To: General Purposes Committee

Date: September 28, 2015

From: Victor Wei, P. Eng.
Director, Transportation

Re: **Update on George Massey Tunnel Replacement Project – Highway 99 Widening**

Att. 1: Map showing potential widening in the Highway 99 corridor

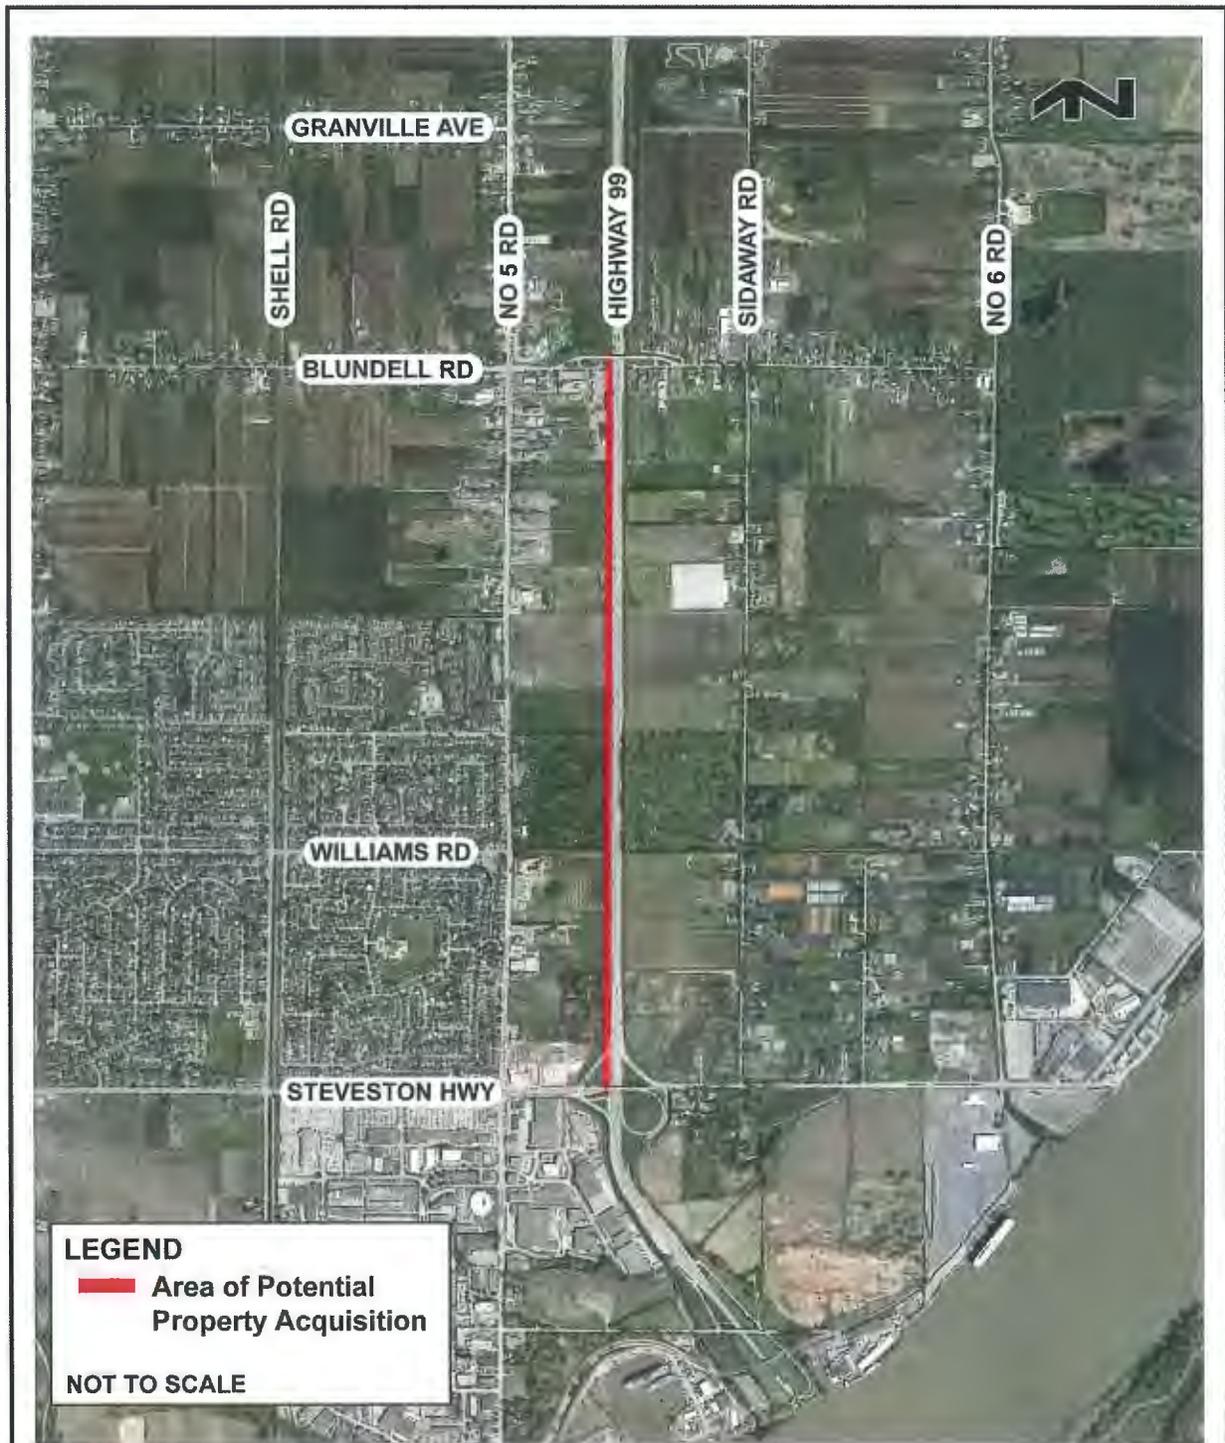
was such that their preference was for any widening of the Highway 99 corridor to be carried out on the west side which was considered by ALC as less actively farmed. See Attachment 1 for a map showing the general area of potential widening of the Highway 99 corridor.

Despite requests from staff for more detailed highway and right-of-way information such as the number of proposed traffic lanes, width of proposed widening and the dimensions of any right-of-way shortages along Highway 99, no such details were shared by the GMTR project team so far. Furthermore, at the time of preparation of this report, no specific information was provided to staff on the extent of the impact on properties or any design drawings for the proposed Highway 99 widening. Hence, at this time, there is insufficient information provided to staff to technically verify the property needs for the widening.
